File Number MV2017Q0033

Type of Operation QUARRY SITE - Existing

Location Quarry along HWY 1 at KM 518 R

Permittee:	Nogha Enterprises	terprises Permit Expiry Date:			
Land Use Permit No.	MV2017Q0033	Previous Inspection:	May 12, 2020		
Quarrying Permit No.	20/0021	Inspection Date:	August 18, 2021		
Contractor:		Subcontractor:			
Location(s) Inspected:	Quarry along HWY 1 at KM 518 R				
Current Stage of	Ongoing				
Operation:					
Program Modifications	N/A				
Approved:

Figure 4 Large Stockpile

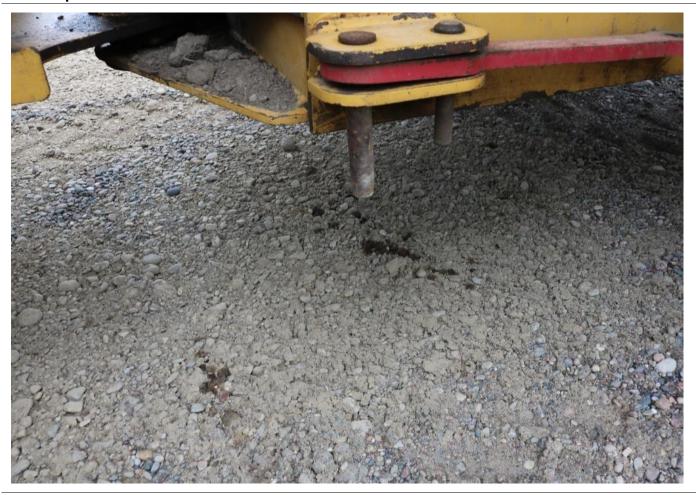
Inspectors from the Department of Lands conducted an inspection of Land Use Permit MV2017Q0033 (Quarry Permit 2020QP0021) on August 18, 2021. The inspection consisted of the quarry along HWY 1 at KM 518 R. There was one large stockpile and two small stockpiles on site. The spill catchment buoys have been removed from the waterbody behind the large stockpile. Vegetation regrowth has been occurring along the old quarry faces.
